# Access Compliance Report Public Rights-of-Way (Curb Ramps)

| Main Street: RANCHWOOD_RD |                                                                   | Cross Street: FAIR_WEATHER_RD |                        | Location:       | W  |
| ADA ID: RPAT211013134801  | Ramp Type:Type 1 - Perpendicular Diagonal Initial Pass/Fail: Fail |                               | Overall Compliance: No | Severity Score: | 15 |

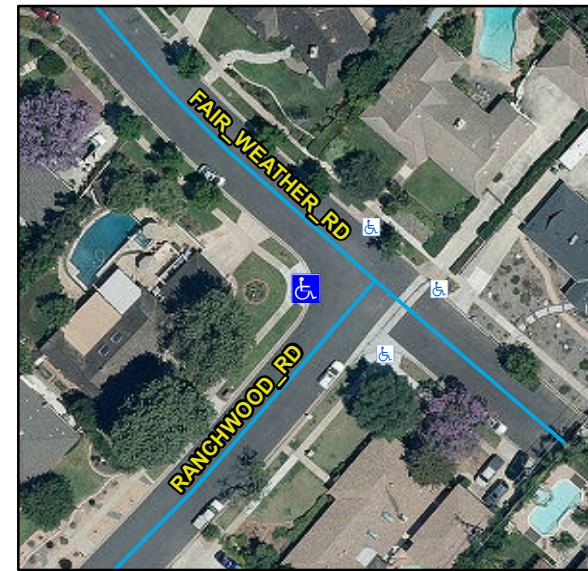
**R304.2.2, R304.5.3, STD 1115**

| Compliance | Description                           | Data | Compliance | Description                   | Data |
|------------|---------------------------------------|------|------------|-------------------------------|------|
| No         | Ramp Cross Slope (%)                  | 5.3  | N/A        | Flare Traversable LT          | N/A  |

**Remove & Replace Curb Ramp With Two New Directional Ramps or Equivalent.**
